Project Reference Code: ERC0222
Submission to the Rule Change Proposal of Generator Technical Performance Standards

1. Comment on S5.2.5.13 (c1) and d(3)

Figure 1: Current transformer accuracy

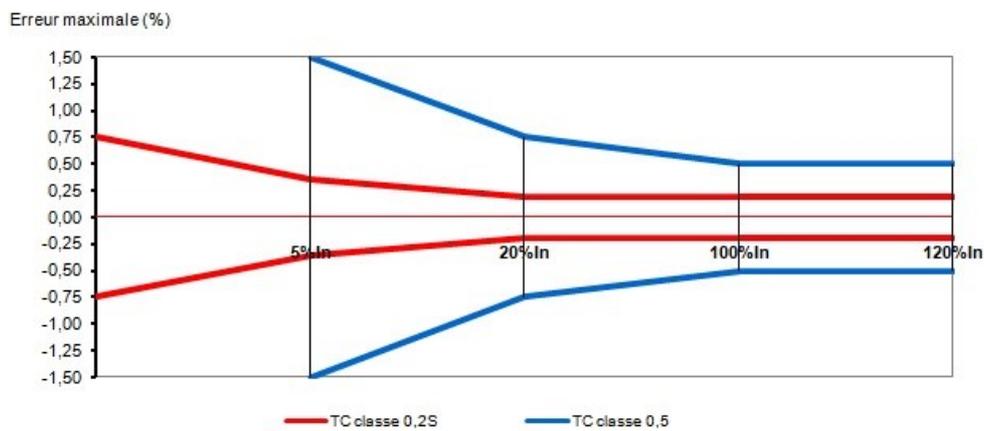
From our experience the required accuracy/tolerance should be expressed in fixed values of MVAR or as a percentage of some other fixed value (rated active or reactive power of the Wind Farm), and not as a percentage of the setpoint itself. If the tolerance is expressed in a percentage of itself, as it is now (*"to within 0.5% of its setpoint"*), it will lead to a very small and technically challenging tolerance. For example, let us say that a Wind Farm operates in a reactive power control mode. If a Wind Farm gets a setpoint of 1 MVAR, the reactive power should be regulated to within only 5 kVAR of this setpoint. Also, this would mean that if a setpoint is set to 0 MVAR, there is no tolerance allowed.

Small tolerance can be technically challenging because of the following reason:

At some point, where the required reactive power setpoint is very small, the tolerance enters an area which is technically not feasible (for no technology) as the

control can't be better than the applied measurement. To regulate the reactive power, the current must be measured. Figure 1 shows industry standard current transformer diagrams. It clearly states, that the accuracy is getting worse, when measuring smaller currents. According to the requirement in S5.2.5.13 (c1 and d3) if the required value of the reactive power is getting smaller the required tolerance is getting smaller as well. In the same time the measurement is getting proportionally worse until at some point it is no longer possible to reach the required tolerance, like shown in Figure 2.

We would therefore like to suggest changing the mentioned requirement and using one of the following forms:

Suggestion 1: Fixed MVAR value

- (1) regulate reactive power or power factor (as applicable) at the connection point, an agreed location in the power system or within the generating system, *to within x MVAR of the setpoint;*

Suggestion 2: *Percentage of fixed value*

- (1) regulate reactive power or power factor (as applicable) at the connection point, an agreed location in the power system or within the generating system, *to within y% of the rated reactive power of the generating system;*

Suggestion 3: *Compromise between the percentage of the setpoint and the percentage of some other fixed value*

- (1) regulate reactive power or power factor (as applicable) at the connection point, an agreed location in the power system or within the generating system, *to within 0.5% of its setpoint or to within z % of the rated power, depending on which yields the highest tolerance;*

Parameters x, y, and z can be set to a desired value. We suggest a value of 0.5% of rated reactive power.

Figure 3: Reactive power control modes – voltage, reactive and power factor control [Draft Rule Determination, page 119]

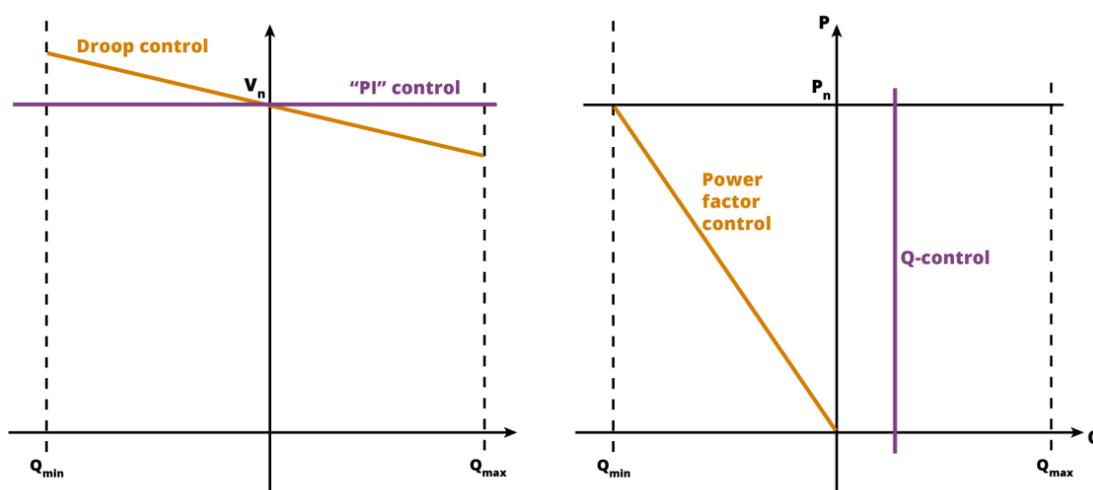
As described in the Draft Rule Determination (page 119) and shown in Figure 3, there are two ways of voltage control, "PI" and droop control.

Whereas the requirements S5.2.5.13 b-2B (i) and d-2B (i) are reasonable for direct "PI" control, we would like to suggest changing the mentioned requirements in case of voltage droop control. For a voltage control with a droop, the tolerance of 0.5% (or 2% for minimum access standard) should relate to the resulting reactive power, and not to the voltage setpoint itself.

Suggestion:

- (i) regulates voltage at the connection point or another agreed location in the power system (including within the generating system) *with the reactive power tolerance band of 0.5% of the rated reactive power*, where that setpoint may be droop-adjusted to incorporate any voltage droop agreed with AEMO and the Network Service Provider;

- (ii) regulate voltage at the connection point, an agreed location in the power system or within the generating system, *with the reactive power tolerance band of 2% of the rated reactive power setpoint*, where that setpoint may be droop-adjusted to incorporate any voltage droop agreed with AEMO and the Network Service Provider;

Figure 4: Example of voltage droop control

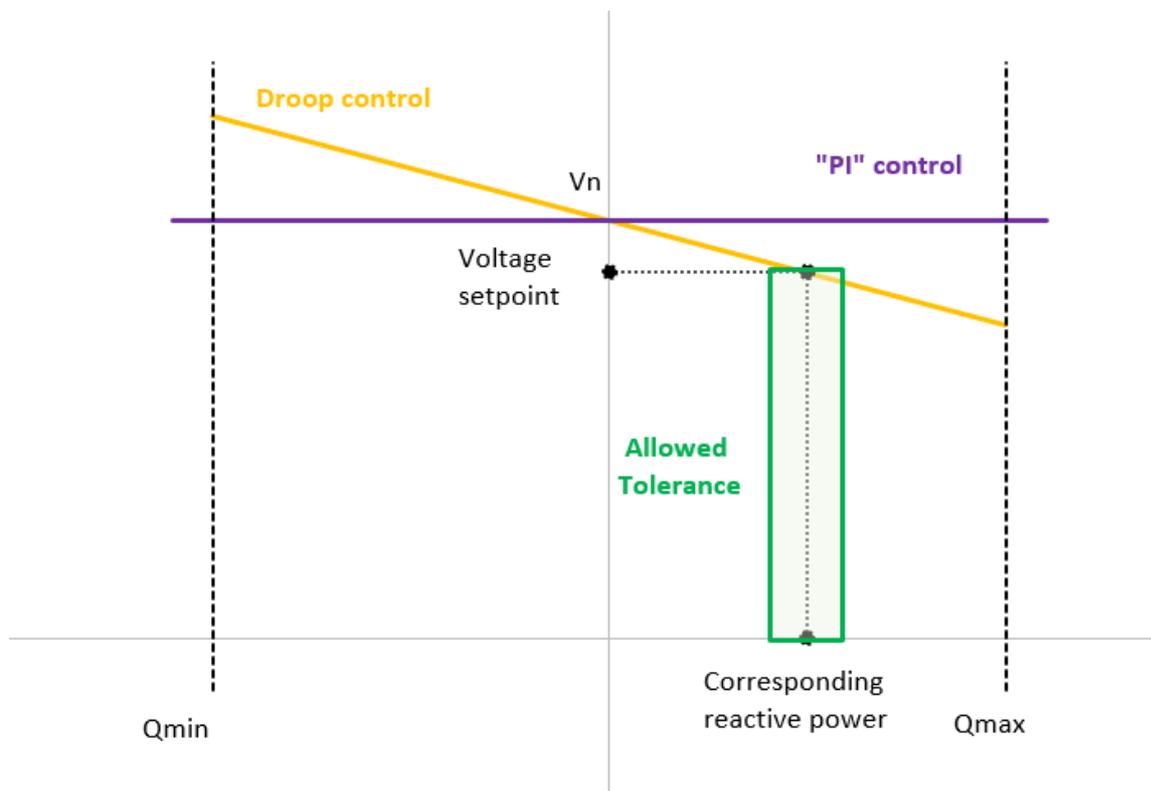
As already explained in the Draft Rule Determination, the droop voltage control is only reacting to voltage deviations. It is not regulating the voltage to an exact voltage setpoint as "PI" control. The allowed tolerance, if expressed in percentage of the voltage setpoint, therefore cannot always be reached. Solution could be expressing the allowed tolerance as the percentage of the reactive power, like shown in Figure 4.
